Dublin Cycling Campaign

16th January 2023

RE: MetroLink Railway Order (Case: 314724)

Below is Figure 2-1 of Appendix A5.7 Construction Vehicles, Plant and Equipment showing the types of HGVs that TII plan to use for the project. HGVs with no direct vision.

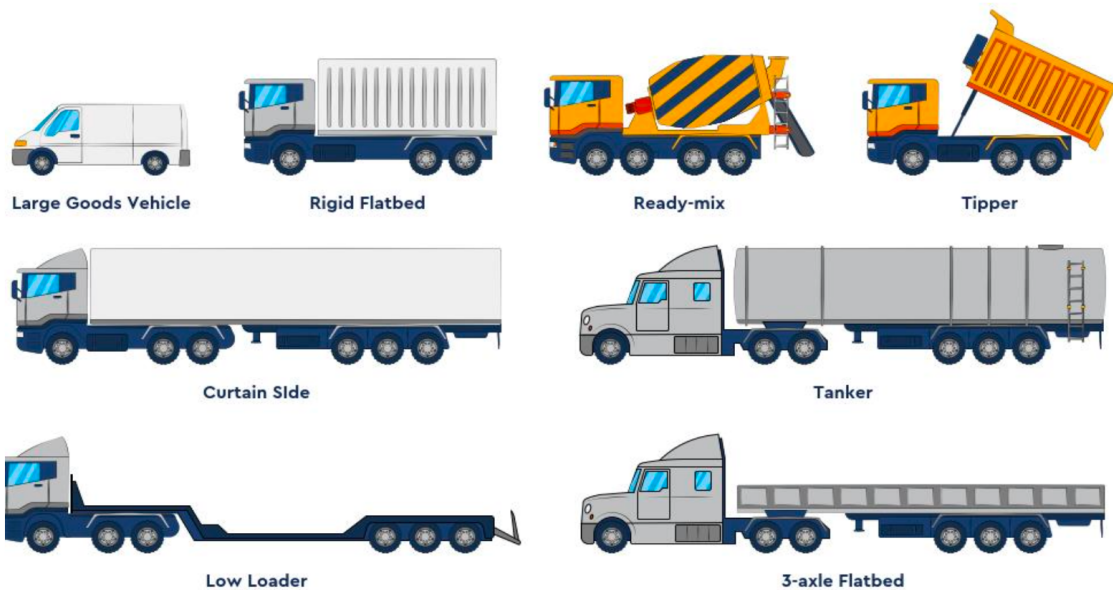
TII's proposed mitigation measures are out of date with the best scientific evidence on how to mitigate the risk to vulnerable road users posed by HGVs. There are standards from other projects that they should implement for MetroLink.

We request that ABP ask TII for further information on how to mitigate this risk, including how cycling will be facilitated safely around construction sites. We also ask ABP to require conditions on HGVs to use the latest technology improvements to reduce the risks of blind spots.
